Case No. 86-AA-Z/SP/PP Filing Fee \$102.00 Date 5-23-86
Applicant JIM PANNELL Phone 722-1111
Mailing Address 1407 S. ALAMO, ROCKWALL TX. 75087

NAME OF PROPOSED DEVELOPMENT PANNELL SUBDIVISION

SITE PLAN REVIEW

PANNELL SUBDIVISION DEVELOPMENT PLAN

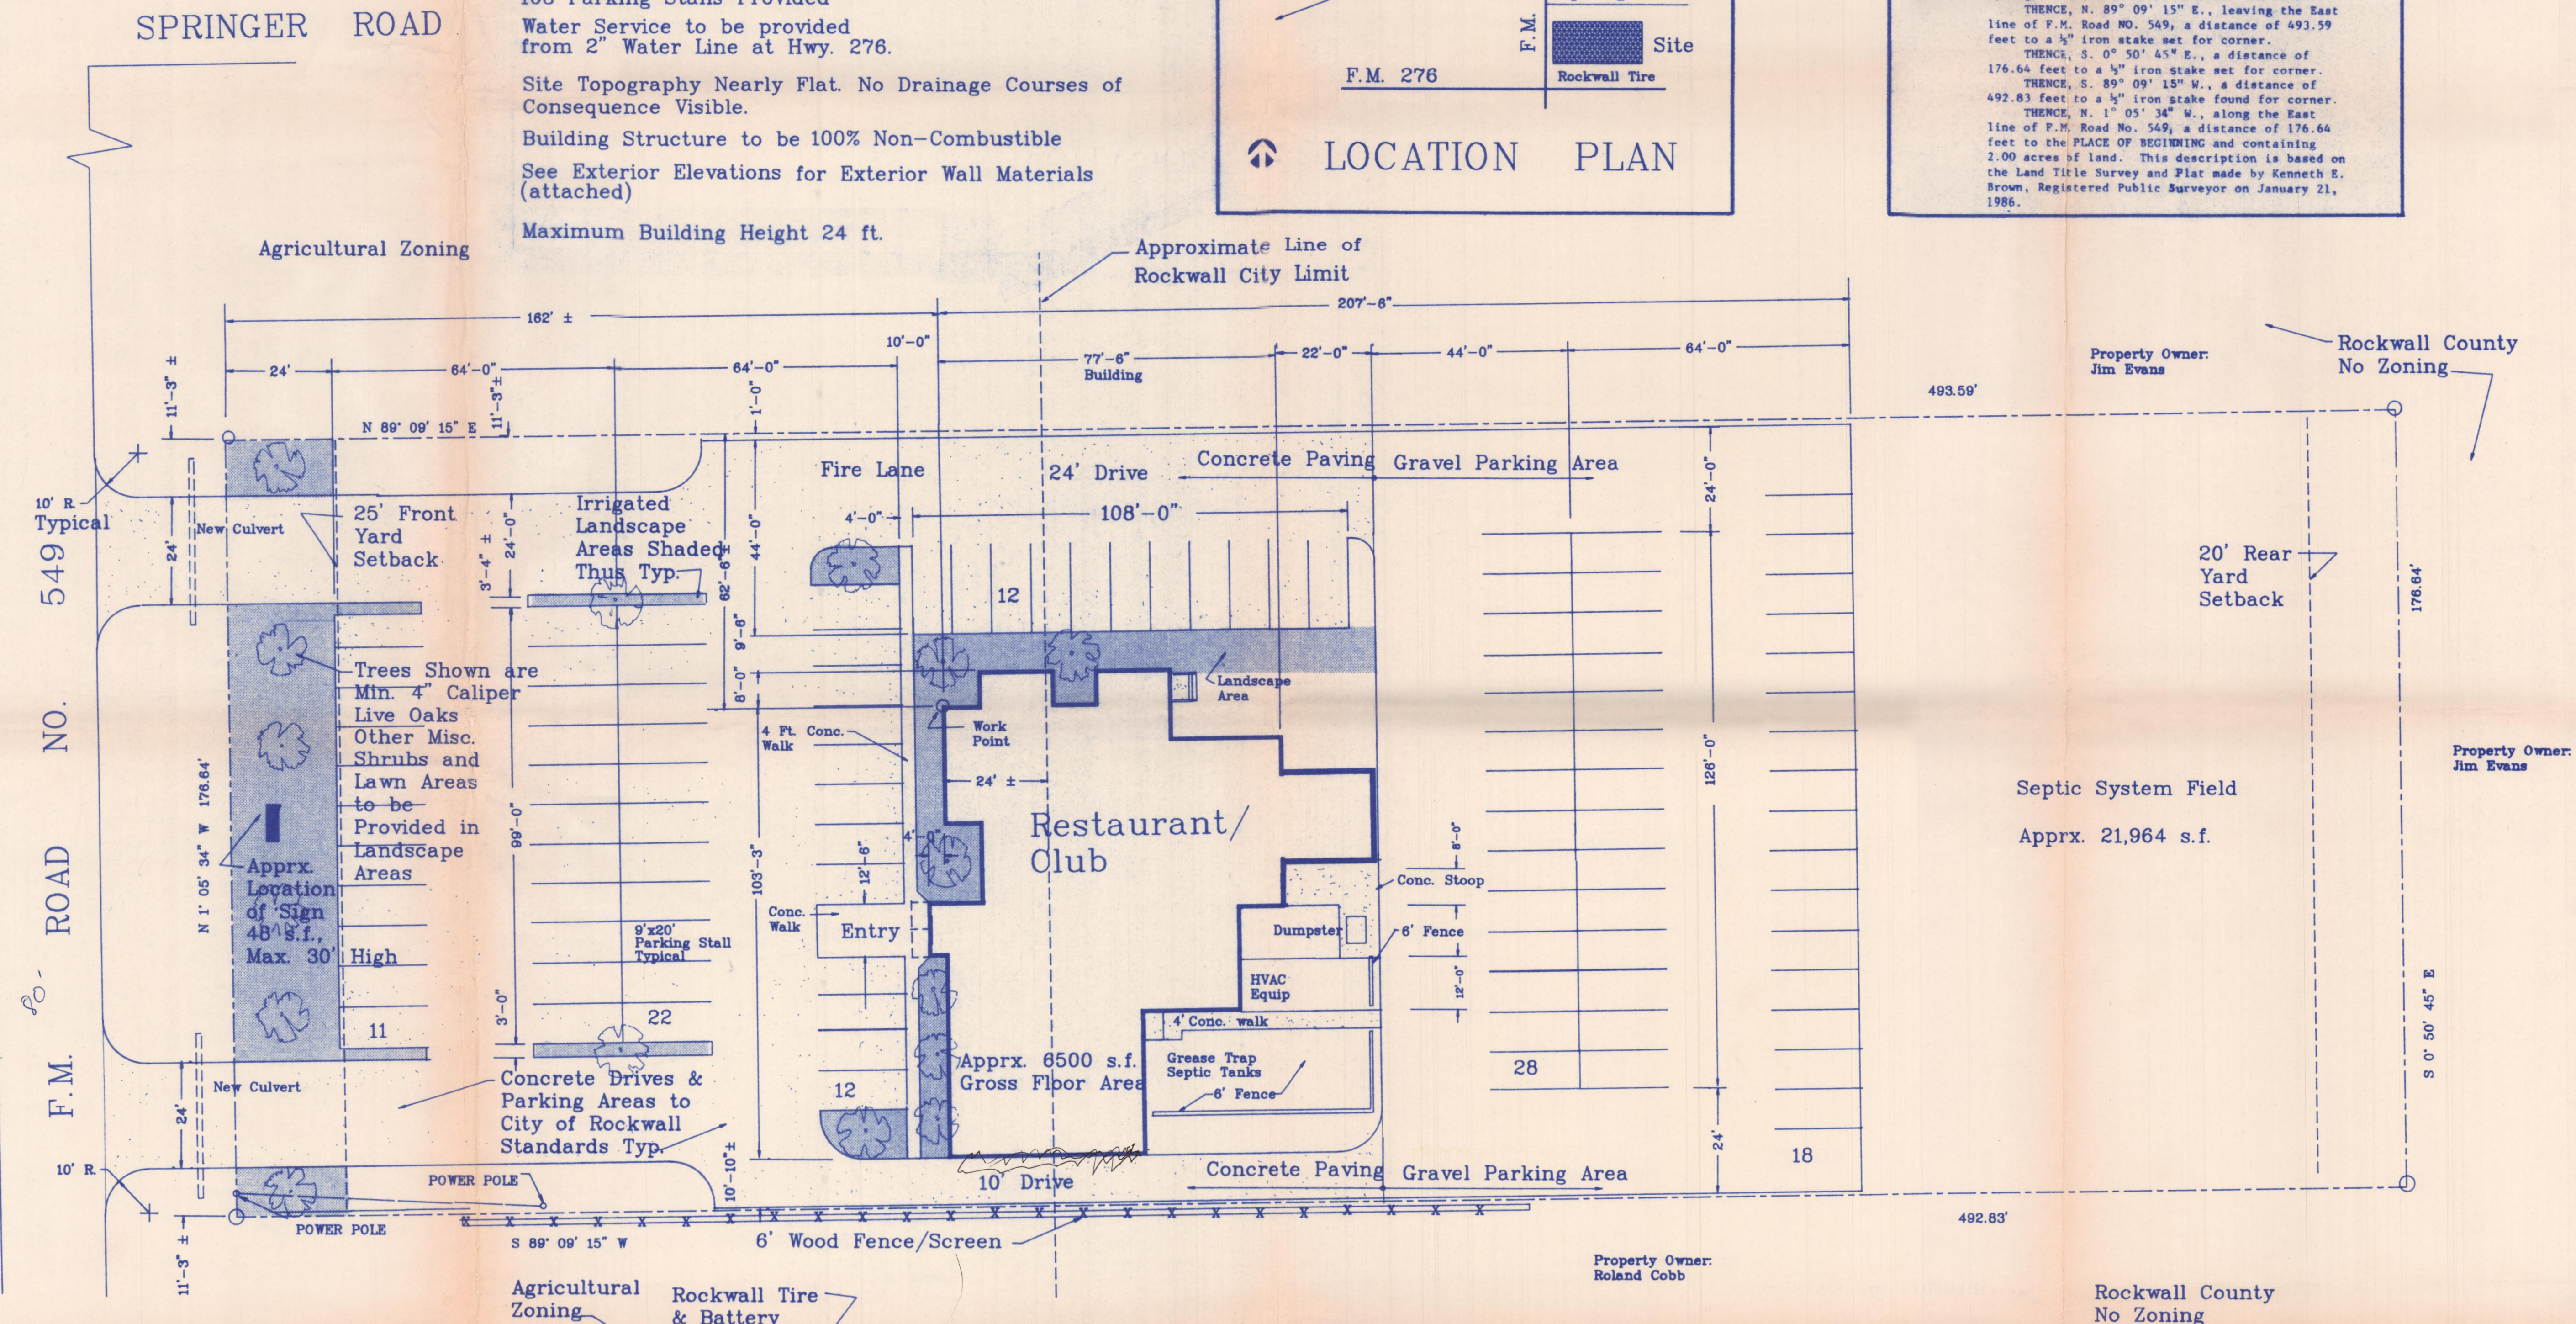
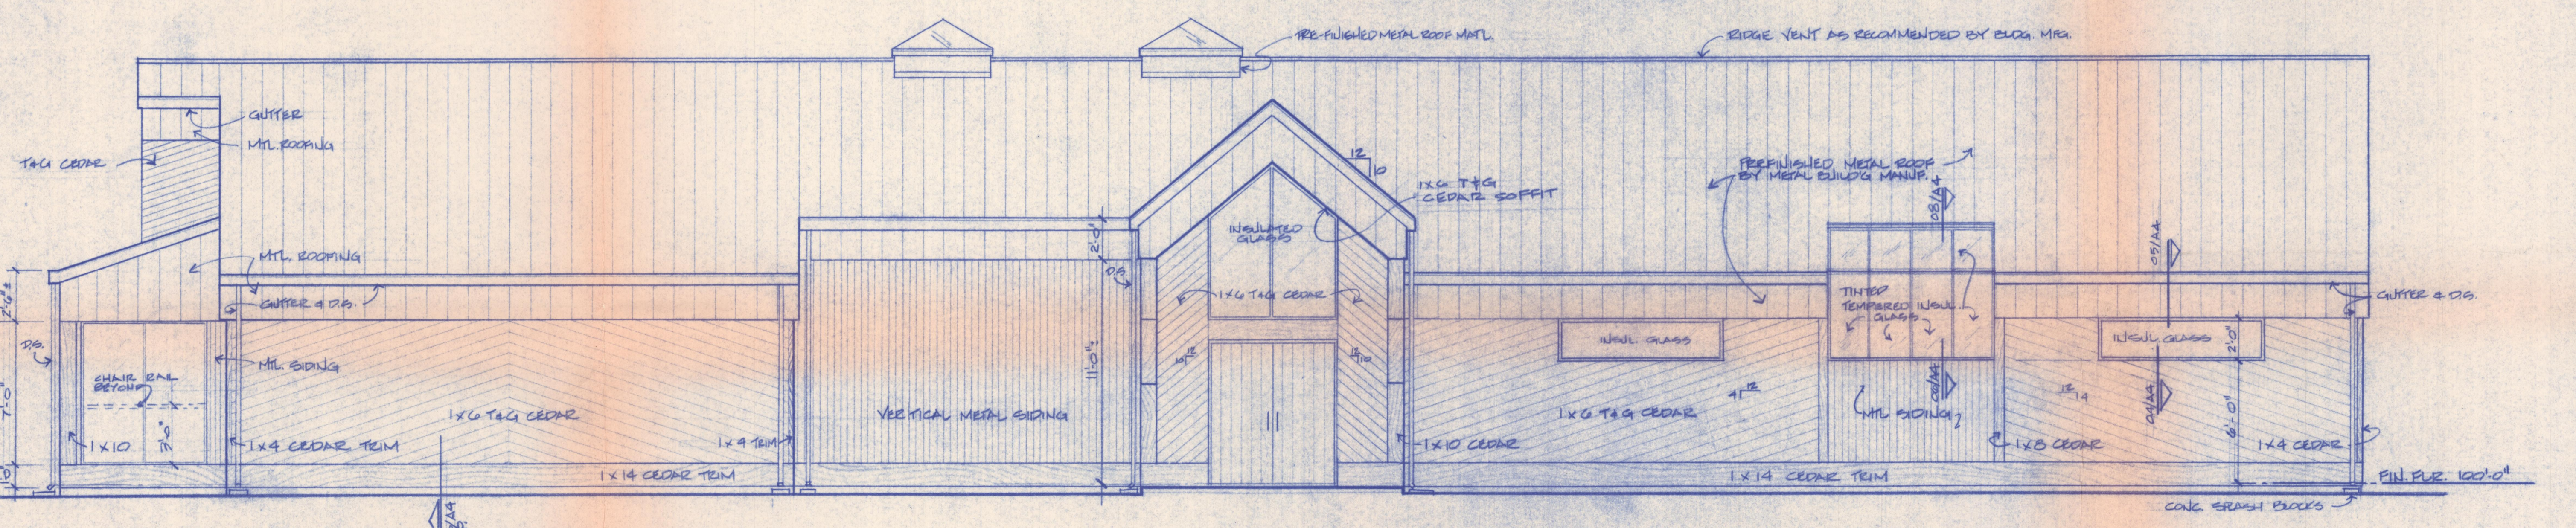
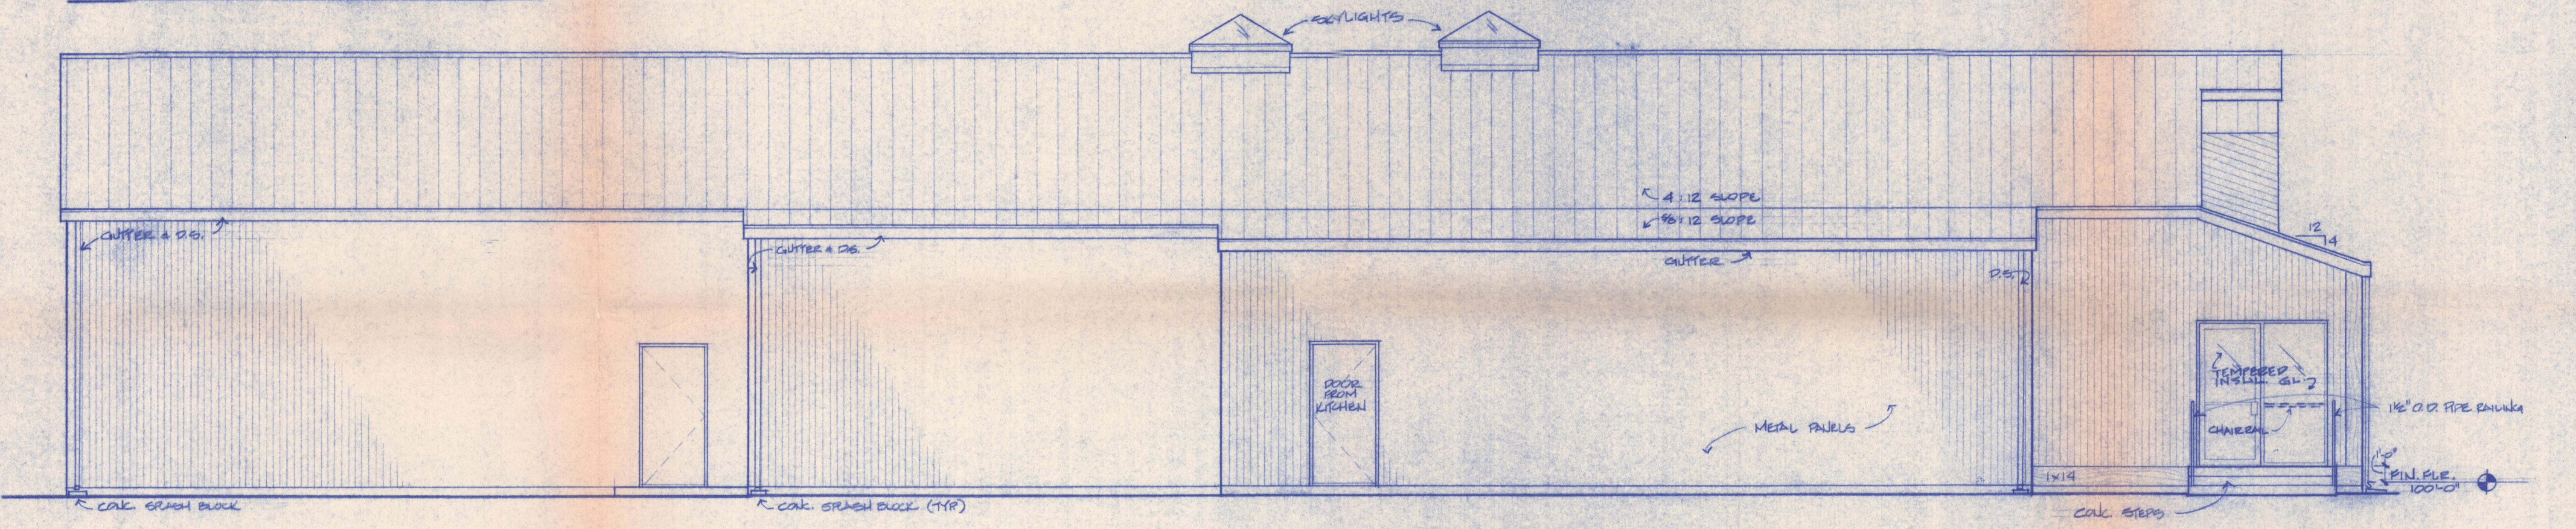
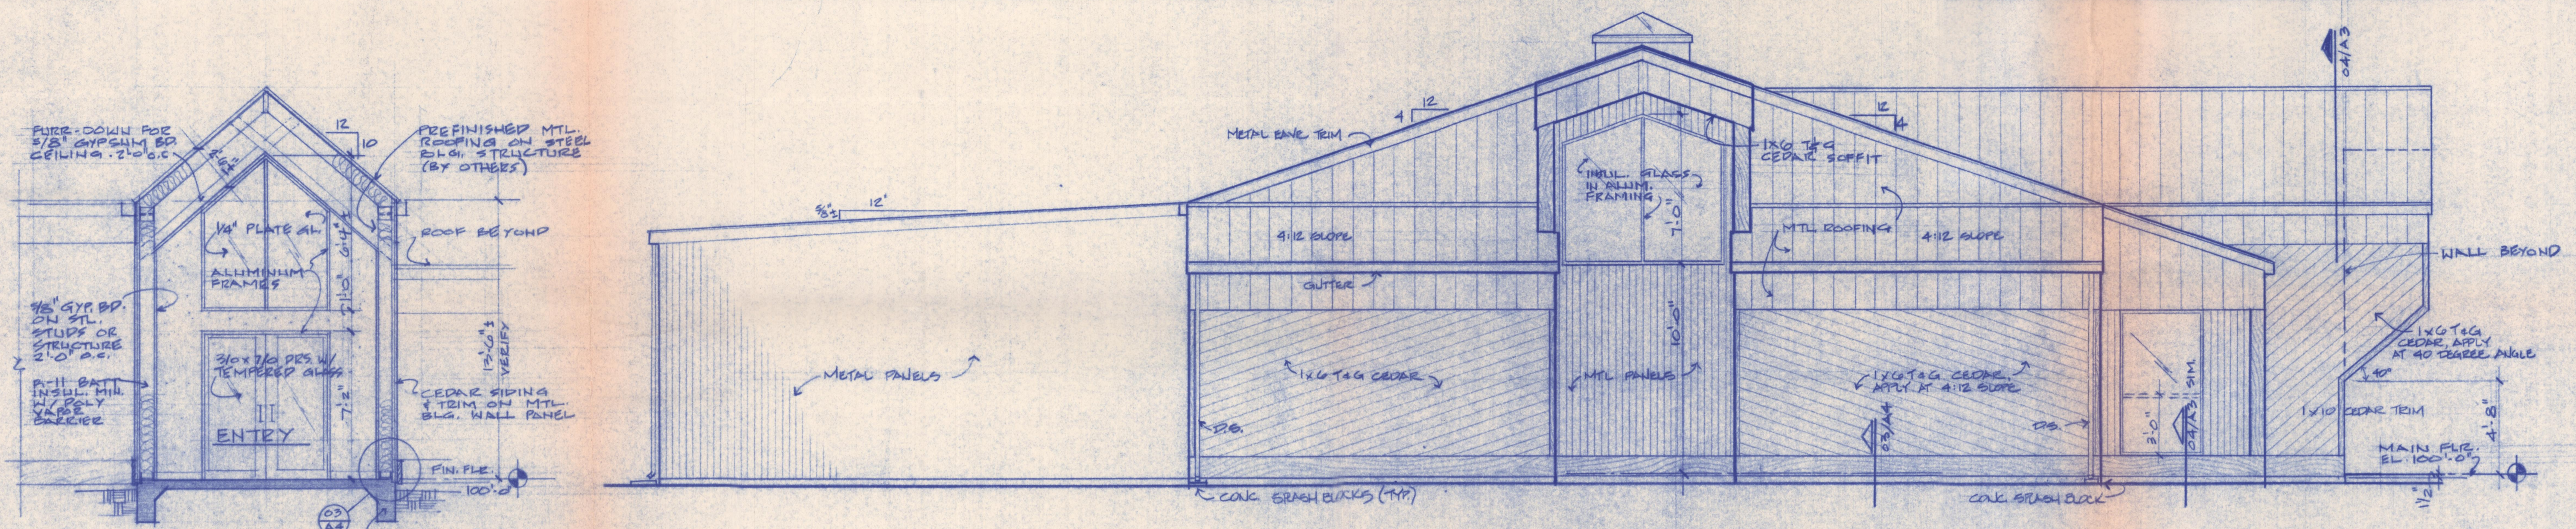
c. Buffering	_____	_____	<input checked="" type="checkbox"/>
d. Landscaping <i>- needs to add 5-10 feet of</i>	_____	_____	_____
<i>need to add 20804 for street</i> <i>add landscaping to parking lot</i>

e. Parking <i>57 in concrete</i>	_____	_____	_____
<i>46 in gravel</i>			
f. Lighting <i>- is the background to be it -</i>	<input checked="" type="checkbox"/>	_____	_____
<i>near or side entrance?</i>

g. Building height	<input checked="" type="checkbox"/>	_____	_____
h. Building Materials <i>will need a waiver in PD.</i>	_____	<input checked="" type="checkbox"/>	_____

<u>Yes</u>	<u>No</u>	<u>N/A</u>
7. Does the site plan contain all required information from the application checklist?	<input checked="" type="checkbox"/>	<input type="checkbox"/>	<input type="checkbox"/>
8. Is there adequate access and circulation? <i>the 10' drive is too narrow side walk to</i>	<input type="checkbox"/>	<input type="checkbox"/>	<input type="checkbox"/>
9. Are street names acceptable? <i>new?</i>	<input type="checkbox"/>	<input type="checkbox"/>	<input checked="" type="checkbox"/>
10. Was the plan reviewed by a consultant? (If so, attach copy of review.)	<input type="checkbox"/>	<input checked="" type="checkbox"/>	<input type="checkbox"/>
11. Does the plan conform to the Master Park Plan?	<input type="checkbox"/>	<input type="checkbox"/>	<input checked="" type="checkbox"/>

drive entrances are not 200' apart - only 104'

1. Do buildings meet setback requirements? <i>is there a fire wall on side</i>	<input checked="" type="checkbox"/>	<input type="checkbox"/>	<input type="checkbox"/>
2. Do buildings meet fire codes? <i>have one side yard of 10ft - fire wall?</i>	<input type="checkbox"/>	<input type="checkbox"/>	<input type="checkbox"/>
3. Do signs conform to Sign Ordinance?	<input type="checkbox"/>	<input checked="" type="checkbox"/>	<input type="checkbox"/>

1. Does plan conform to Thoroughfare Plan? <i>needs to show 20' ded.</i>	<input type="checkbox"/>	<input checked="" type="checkbox"/>	<input type="checkbox"/>
2. Do points of access align with adjacent ROW?	<input type="checkbox"/>	<input type="checkbox"/>	<input checked="" type="checkbox"/>
3. Are the points of access properly spaced? <i>need 200' they have 104'</i>	<input type="checkbox"/>	<input checked="" type="checkbox"/>	<input type="checkbox"/>
4. Does plan conform with Flood Plain Regulations?	<input checked="" type="checkbox"/>	<input type="checkbox"/>	<input type="checkbox"/>
5. Will escrowing of funds or construction of substandard roads be required? <i>176.64' of frontage & 2 lanes</i>	<input checked="" type="checkbox"/>	<input type="checkbox"/>	<input type="checkbox"/>

11. Does the plan exhibit good planning in general layout, access, and vehicular and pedestrian circulation?	<input checked="" type="checkbox"/>	<input type="checkbox"/>	<input type="checkbox"/>
<i>except for 10' drive along side - too narrow unless only for service for employees?</i>

d. Is any additional right-of-way required? <i>need 20' on FM-549</i>	<input checked="" type="checkbox"/>	<input type="checkbox"/>	<input type="checkbox"/>

e. Is there adequate road access to the proposed project?	<input checked="" type="checkbox"/>	<input type="checkbox"/>	<input type="checkbox"/>
f. Will escrowing of funds or construction of substandard roads be required? <i>176.64' of funds x 2 lanes</i>	<input checked="" type="checkbox"/>	<input type="checkbox"/>	<input type="checkbox"/>

1. Water	<input checked="" type="checkbox"/>	_____	_____
2. Sewer	_____	_____	<input checked="" type="checkbox"/>
d. Is there adequate capacity in sewer outfall mains, treatment plants and water transmission lines to handle the proposed development? <i>not adequate water service</i>	_____	<input checked="" type="checkbox"/>	_____

- (1) That the 10' South access drive to the rear parking lot be deleted.
- (2) That all escrow requirements for street & water line be met.
